# Hornsea Project Four

## Written Summary of the Applicant's Oral Case at Issue Specific Hearing 4

**Document Reference: G4.4**

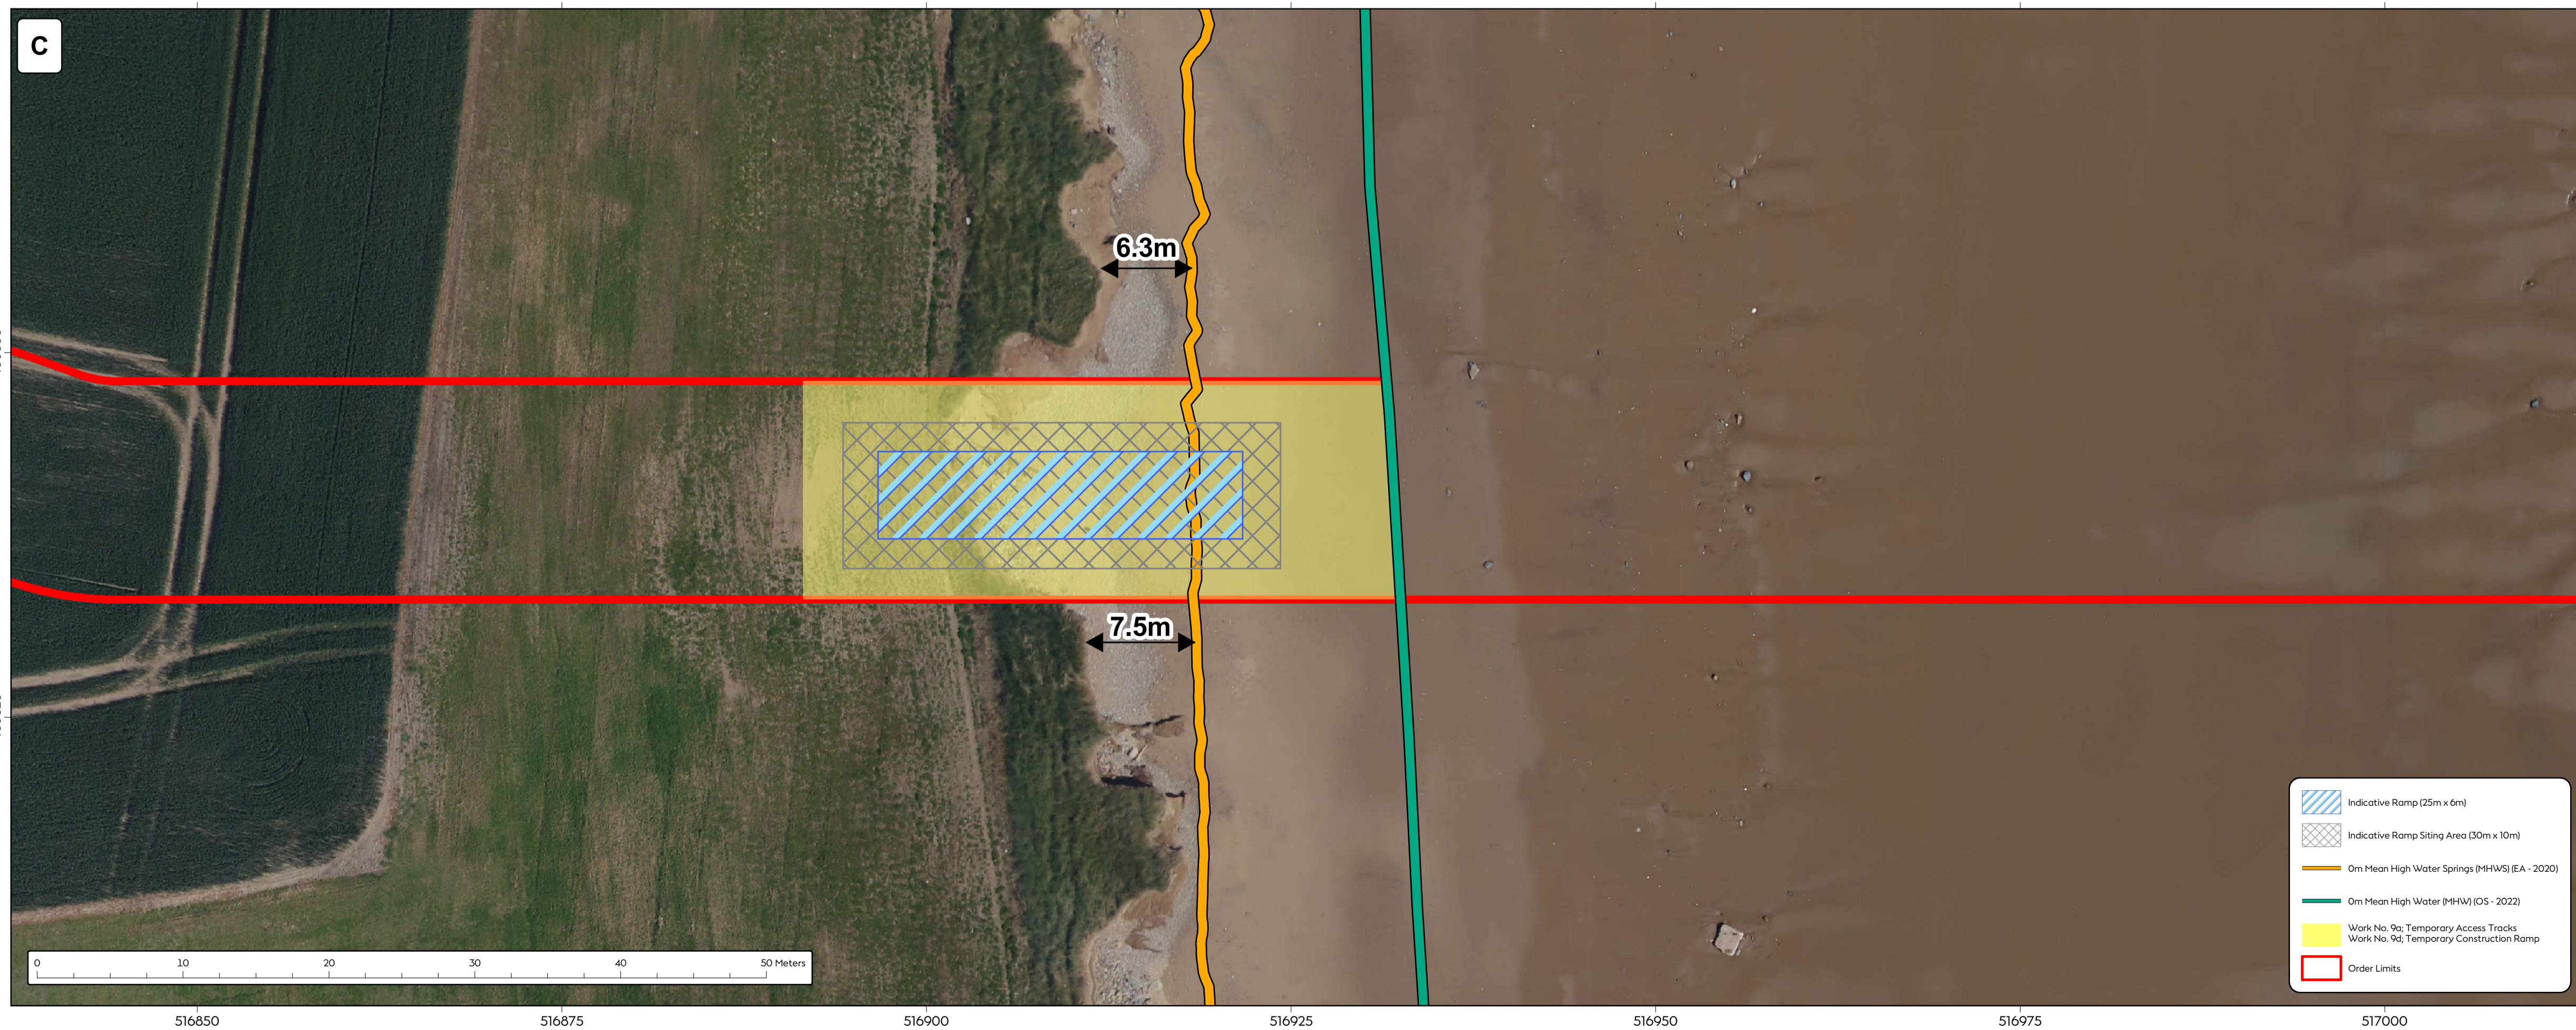
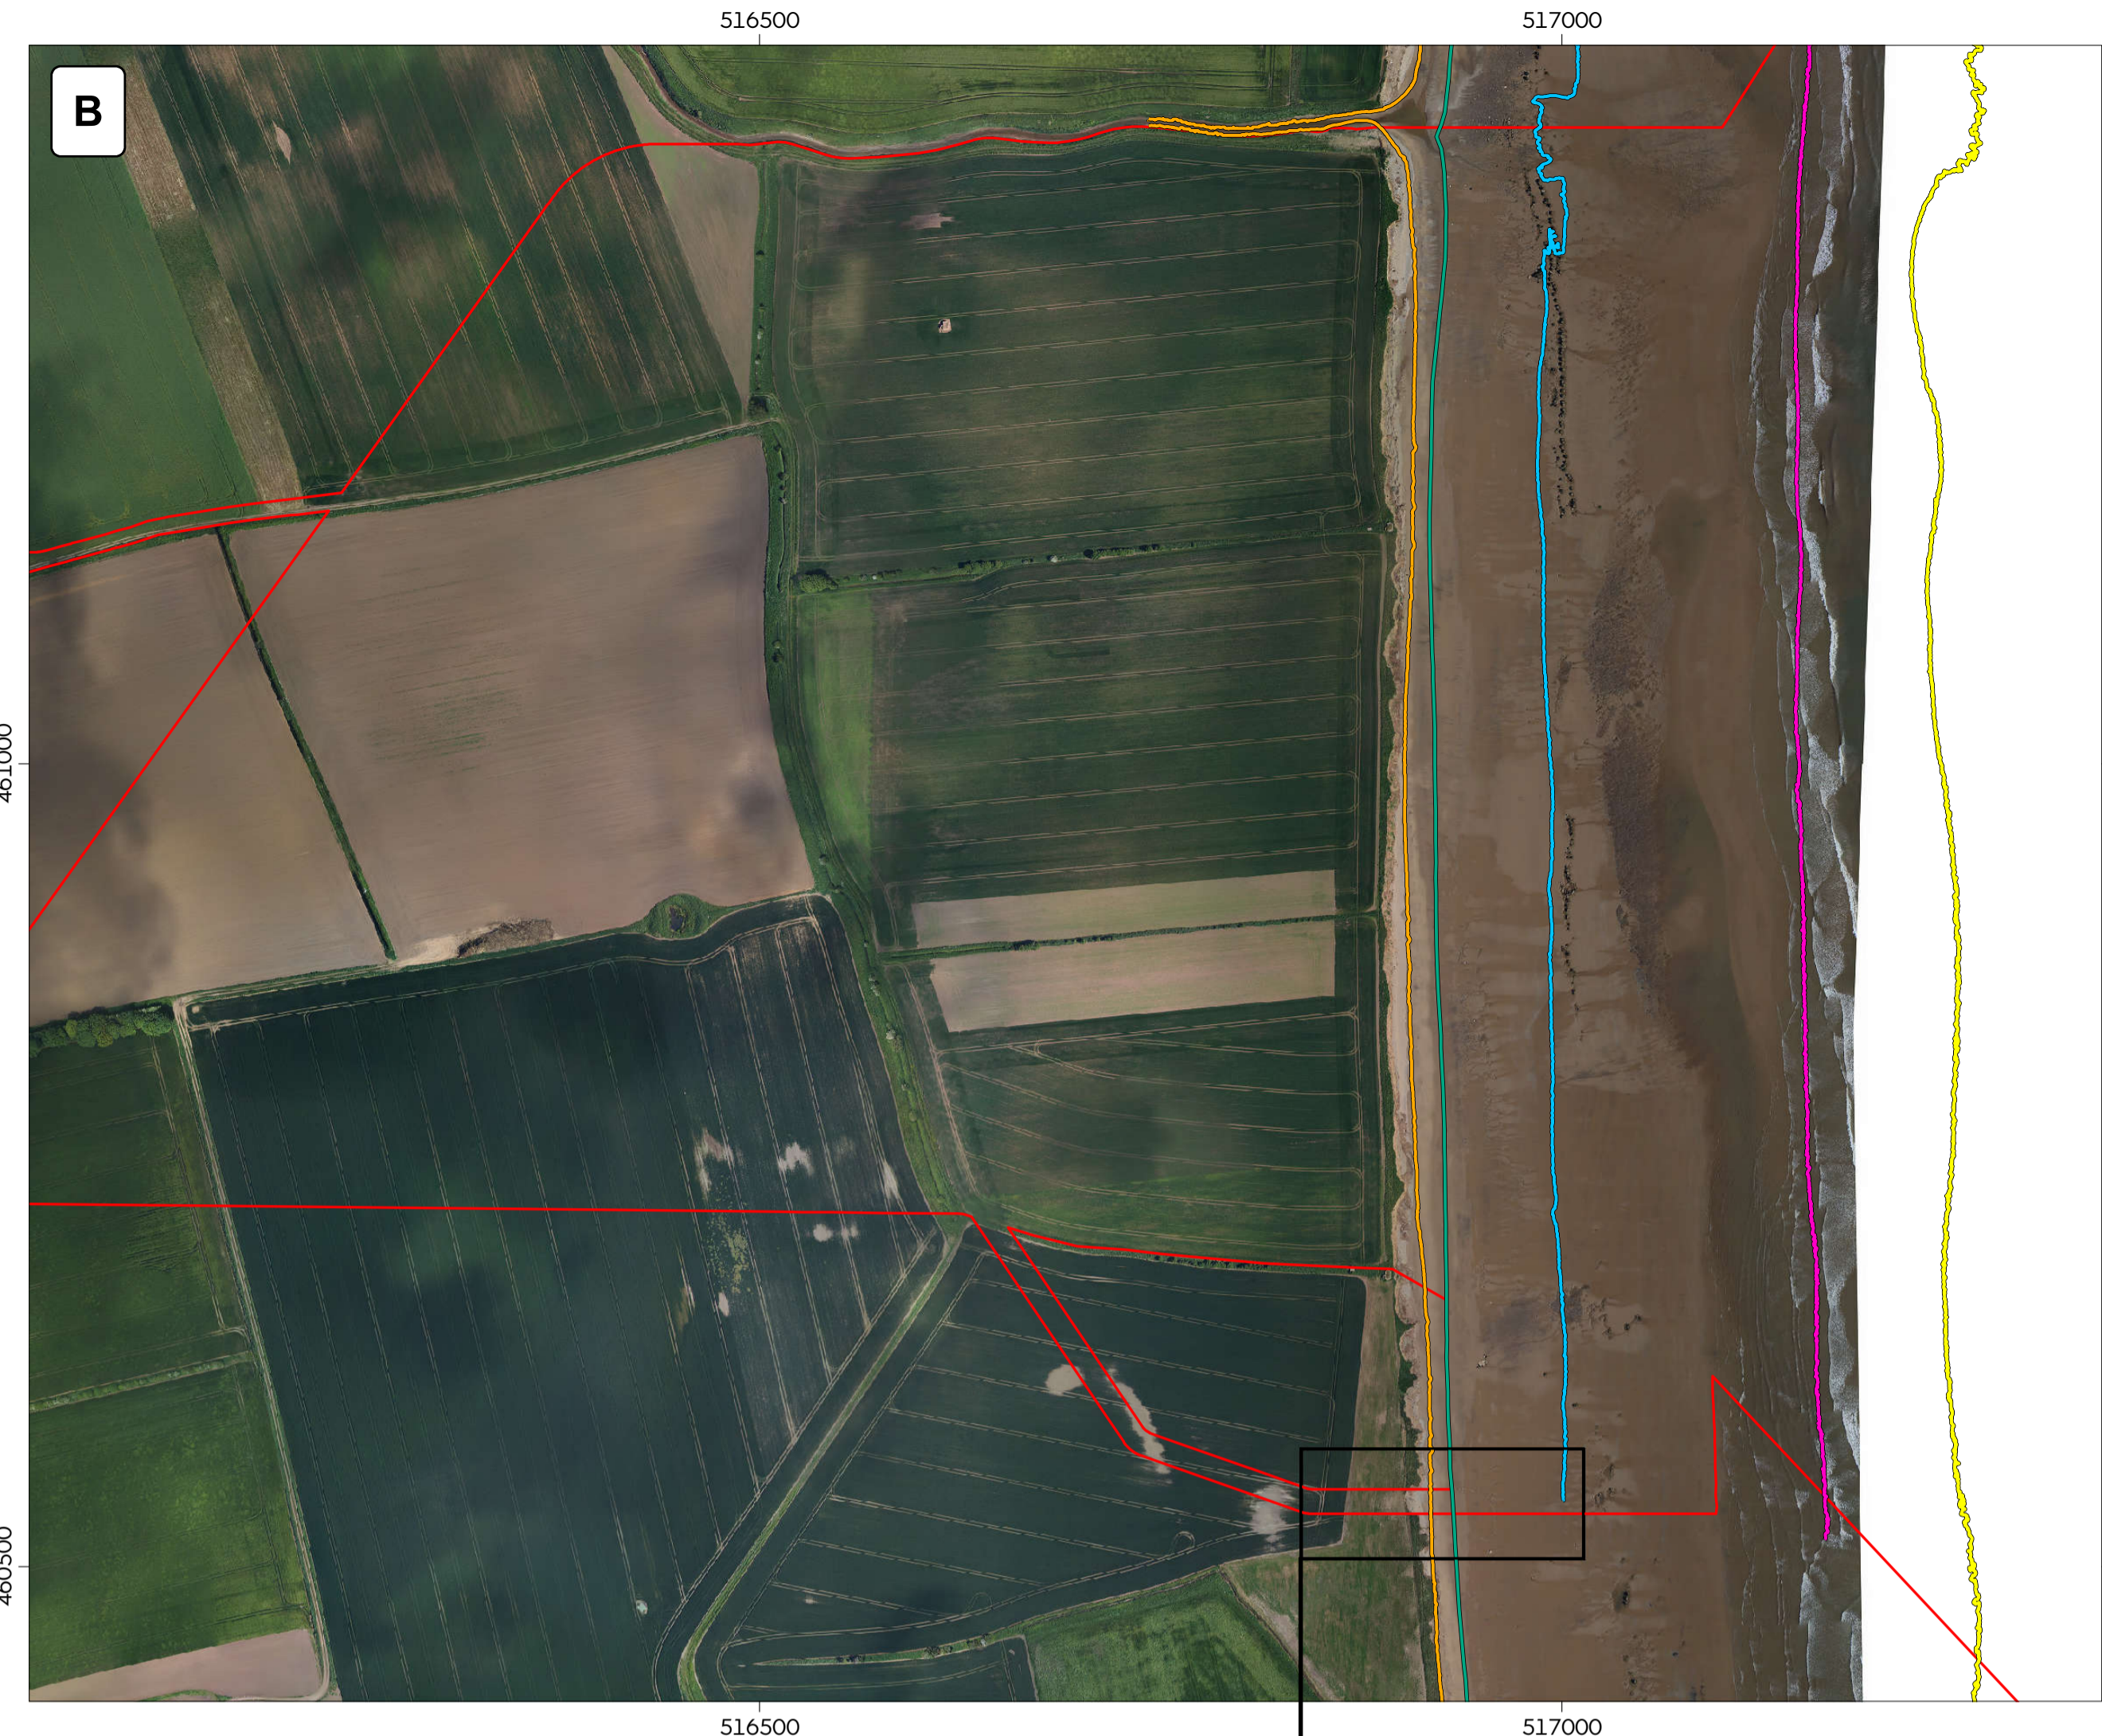
Action	Description	Action by	Deadline	Applicant's Comment/where has the action been answered.
1	<p>Further consideration of the definition and mapping of the eastern boundary of Works Area 9d (temporary ramp to beach) on the Works Plans as the geographical position of Mean High Water Springs varies according to beach level, and if it moved westward the base of the ramp could intrude into the intertidal zone.</p>	Applicant	4	<p>The Applicant is still considering this issue and will provide a response at Deadline 5.</p>
2	<p>Provide definition and description of any activities and works that might be carried out on the beach in works area 9a ('temporary vehicular access tracks'). Confirm responsibility and process for monitoring activities and enforcement of mitigation in regard to works area 9d and 9a where in the intertidal zone.</p>	Applicant	4	<p>The activities likely to be carried out on the beach in works area 9a ('temporary vehicular access') are in emergency only. It is highly probable that the vehicular access to the foreshore may not be required. Should vehicular access be required it is likely to comprise:</p>

# Hornsea Project Four Offshore Wind Farm Landfall Access Ramp and Tidal Levels

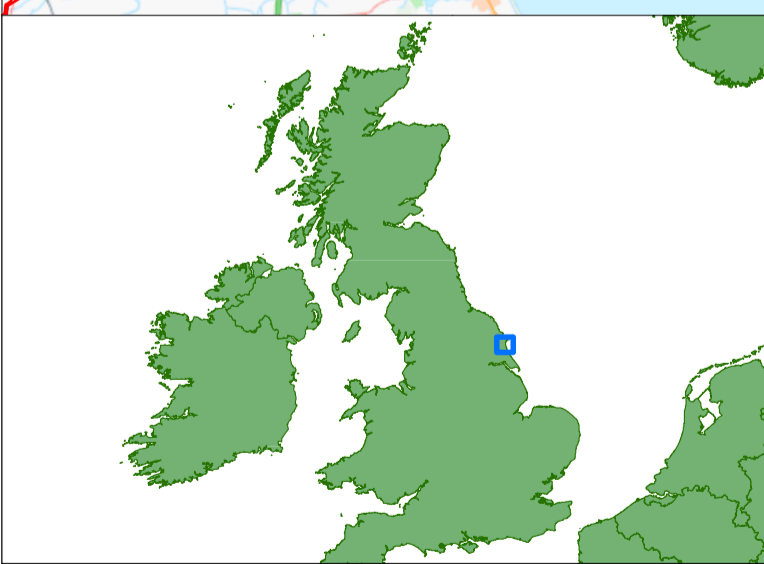
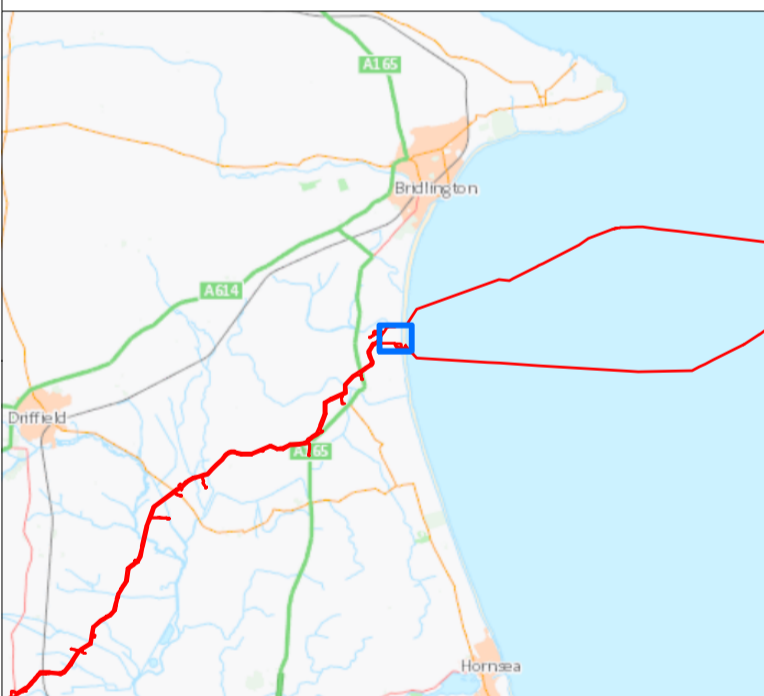
2.1	The ExA asked the Applicant to provide an update on the location and monitoring of the access ramp. At Compulsory Acquisition Hearing 1, the ExA noted that Ms Brodrick on behalf of the Applicant explained that the ramp carried an access track to the beach for emergencies only, in the event that the horizontal directional drilling ("HDD") failed. The ExA asked the Applicant to confirm that this access ramp was covered by work no. 9d on the Works Plans and shaded orange and green.	<p>Mr McGovern, on behalf of the Applicant, confirmed that was correct.</p> <p>The ExA asked the Applicant to elaborate on the purpose of the landfall access ramp, what would be done to create it, and what it would look like once built. Mr McGovern noted that as explained by Ms Brodrick, the ramp would be used for emergency access to the beach. The method of construction and the nature of the ramp is described more particularly in the Project Description (APP-010) and Mr McGovern noted that there were some useful illustrations of the construction method shown on inset plates in ES figure 4.16. Broadly speaking, the method of construction would be to lower bags of sand or rock to be level with the cliff face and then to lay a surface on top. There would be no excavation of the cliff face as part of construction.</p> <p>The ExA asked where the material for the sandbags would be sourced from. Dr Carolan, on behalf of the Applicant, noted that the aggregate for the sandbags would be brought on site from external sources and stored in the landfall site construction compound before being lowered to the level of the toe of the cliff. Dr Carolan noted that ES figure 4.16 of the Project Description shows a number of insets. Inset A shows the running boards on top of which would be placed the bridge which would run from landfall to the beach.</p>

The ExA asked whether there would be any impact on the cliff profile and Dr Carolan confirmed there would not be any such impact. Dr Carolan confirmed there would be no excavation works and works would be above mean high water springs ("MHWS"). Mr Maclachlan on behalf of ERYC asked if the structure would be located within the intertidal zone. Mr McGovern confirmed that he understood it would not be.

The ExA asked the Applicant to confirm that the location and extent of the access ramp is correctly shown on the Works Plans and asked what delineates the eastern boundary of the structure. Mr McGovern advised that the Applicant believed the extent and location had been accurately shown on the Works Plans and that the eastern extent is above MHWS. Mr McGovern confirmed the Applicant was happy to submit a revised plan showing MHWS at Deadline 4. The Applicant refers the ExA to Appendix A: Figure showing spatial extent of activities in the coastal and intertidal zone. Inset A shows the extent of the access ramp in relation to Works No 9a (Inset A). The tidal limits are presented in Inset B of the same figure. Inset C delineates the eastern boundary of the structure (25 x 6 m) within the upper intertidal.

The ExA thanked the Applicant but asked whether, since MHWS changes according to beach profile, this was a satisfactory way of delineating the works. Dr Carolan for the Applicant noted that coastal erosion is monitored by ERYC and has been factored into the baseline. While there may be long-term changes to the beach profile, this is not anticipated to affect the representation of the tidal limits during a three-year construction period, which as shown on Inset B of Appendix A, vary naturally in relation to the variation of tidal limits at the site.

**Post-hearing clarification.** Inset A of Appendix A shows the spatial extent of the running boards (indicative ramp siting area (30 x 10 m) in Appendix A of this document), on top of which would be placed the bridge (indicative ramp (25 x 6 m) in Appendix A of this document) which would run from landfall to the beach.

**Post-hearing clarification.** The Applicant refers to Appendix A (Figure showing spatial extent of activities in the coastal and intertidal zone) and confirms there would be minimal works between mean high water springs ("MHWS") and mean high water (MHW).

<p>Following discussion between the ExA and ERYC, the ExA concluded that it accepted the Applicant's offer of a revised Works Plan showing MHWS in relation to the access ramp (see Appendix A). Mr McGovern confirmed the Applicant would consider the consequences of a change in MHWS however he noted that coastal erosion had been factored into the maximum design scenario. Please see Applicant's further submission in response to action point 1 below.</p> <p>The ExA highlighted Work No. 9a and stated that this seemed to be from MHWS to MLWS. Schedule 1 to the DCO shows Works No. 9a to be temporary vehicular access tracks. The ExA asked the Applicant what form these would take and whether an assessment had been undertaken of their impact.</p> <p>Mr McGovern confirmed that the Applicant would provide further detail in writing. The precise area where access may be needed is unpredictable which is why a large area has been highlighted, but the Applicant confirmed that only light vehicles or light excavation vehicles would need to use the access tracks. Please see Applicant's further submission in response to action point 2 below.</p>
